BROWNS FERRY NUCLEAR PLANT - IMPROVED TECHNICAL SPECIFICATIONS

SECTION 3.1

LIST OF REVISED PAGES

UNIT 1 ITS SECTIONS

~~3.3/4.3 REACTIVITY CONTROL~~

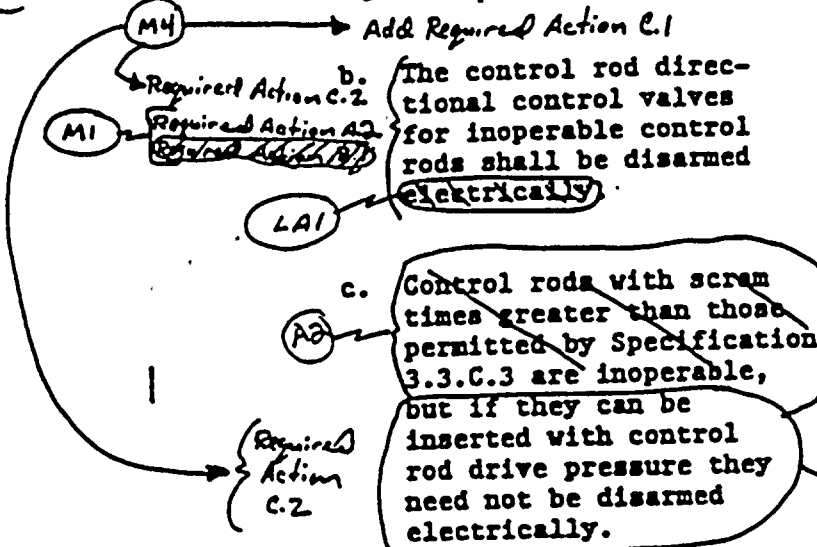
See Justification for Change for Proposed Specification 3.1.5

Add 2nd Part of Proposed Condition E

Specification 3.1.3

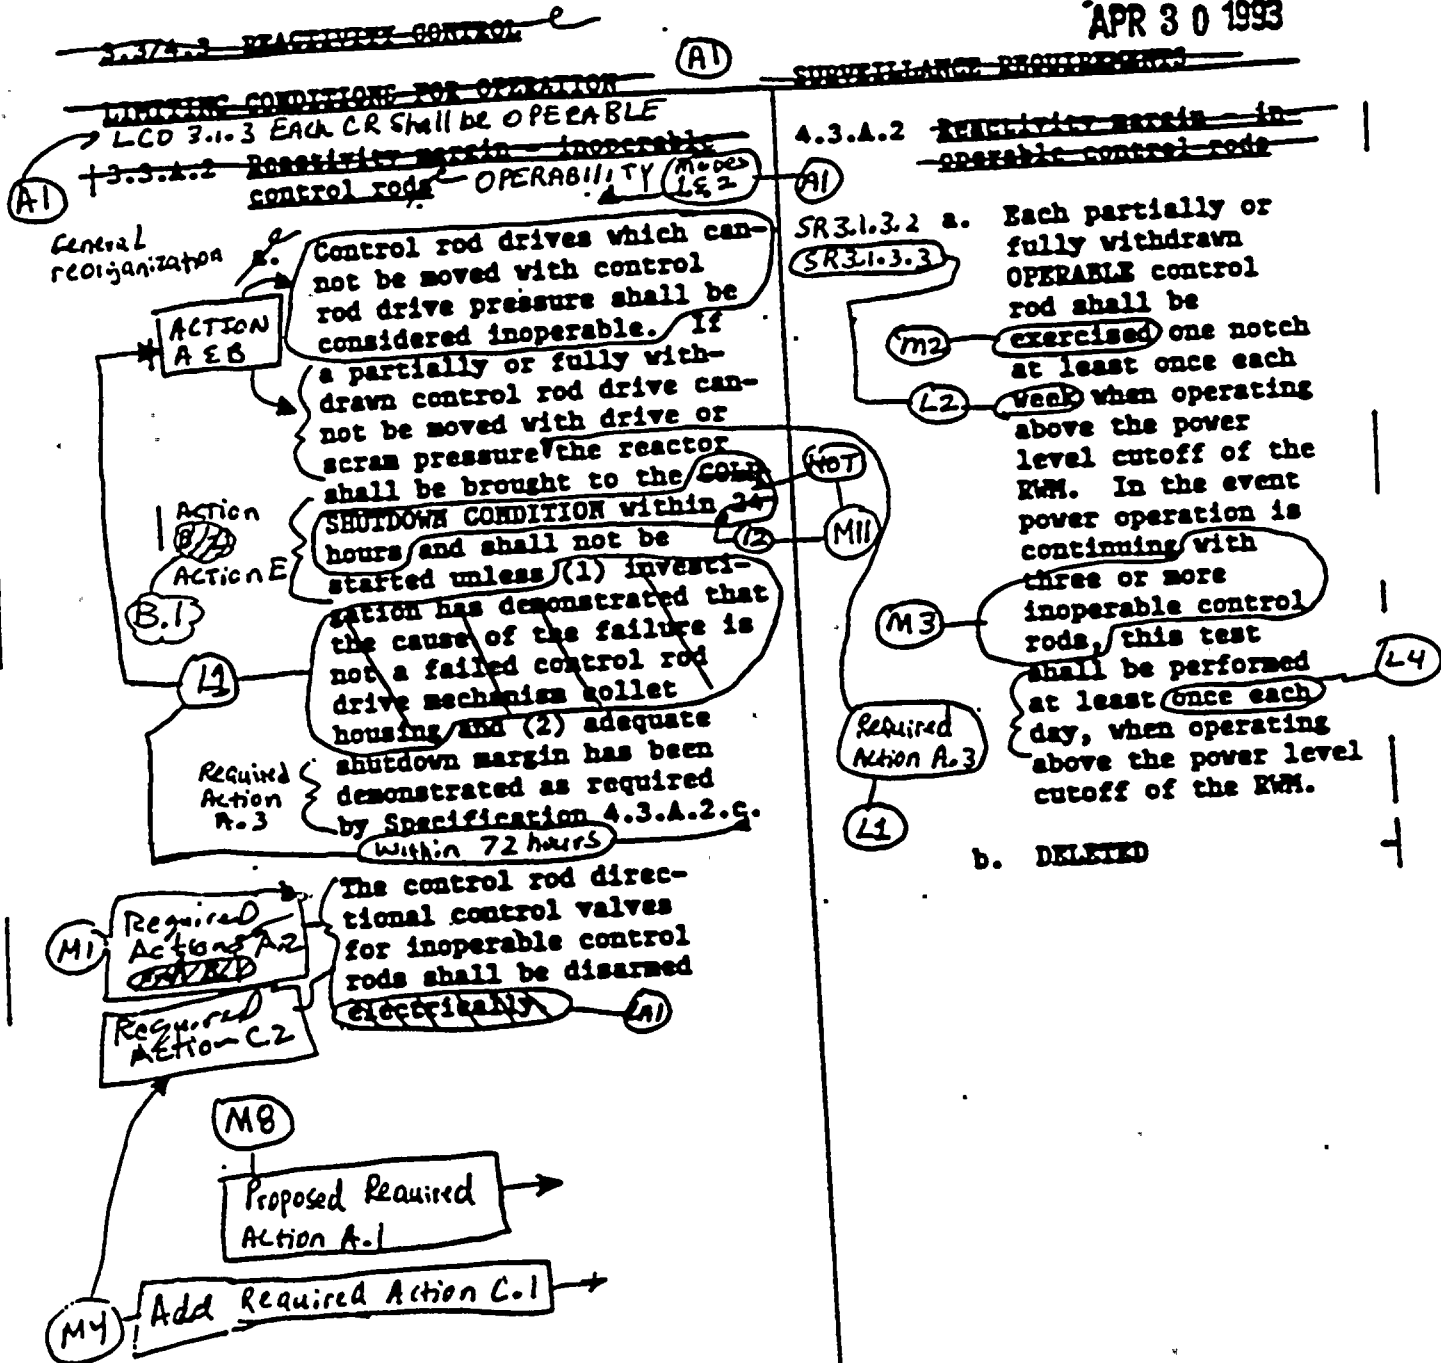
Add 2nd Part of Proposed Condition E

Add Table 3.1.4-1, Notes 1

SR 3.1.4.3

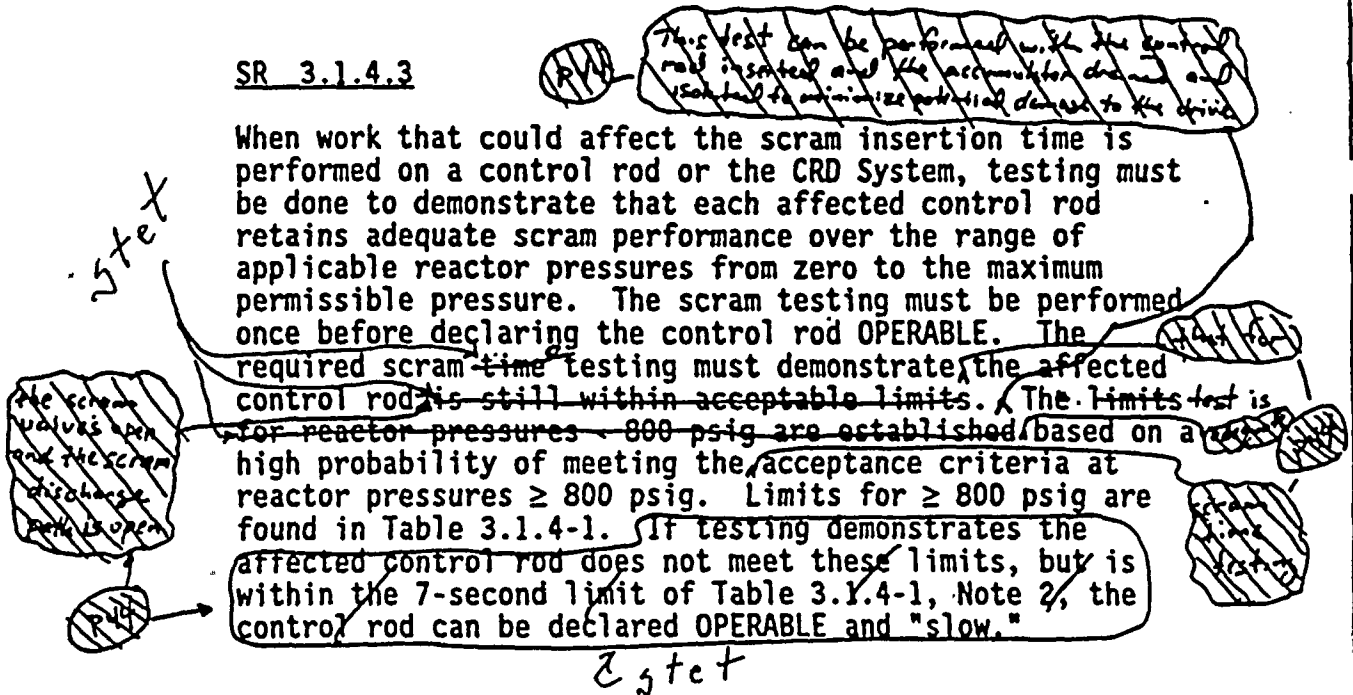
When work that could affect the scram insertion time is performed on a control rod or the CRD System, testing must be done to demonstrate that each affected control rod retains adequate scram performance over the range of applicable reactor pressures from zero to the maximum permissible pressure. The scram testing must be performed once before declaring the control rod OPERABLE. The required scram-time testing must demonstrate the affected control rod is still within acceptable limits. The limits test is for reactor pressures ≥ 800 psig are established based on a high probability of meeting the acceptance criteria at reactor pressures ≥ 800 psig. Limits for ≥ 800 psig are found in Table 3.1.4-1. If testing demonstrates the affected control rod does not meet these limits, but is within the 7-second limit of Table 3.1.4-1, Note 2, the control rod can be declared OPERABLE and "slow."
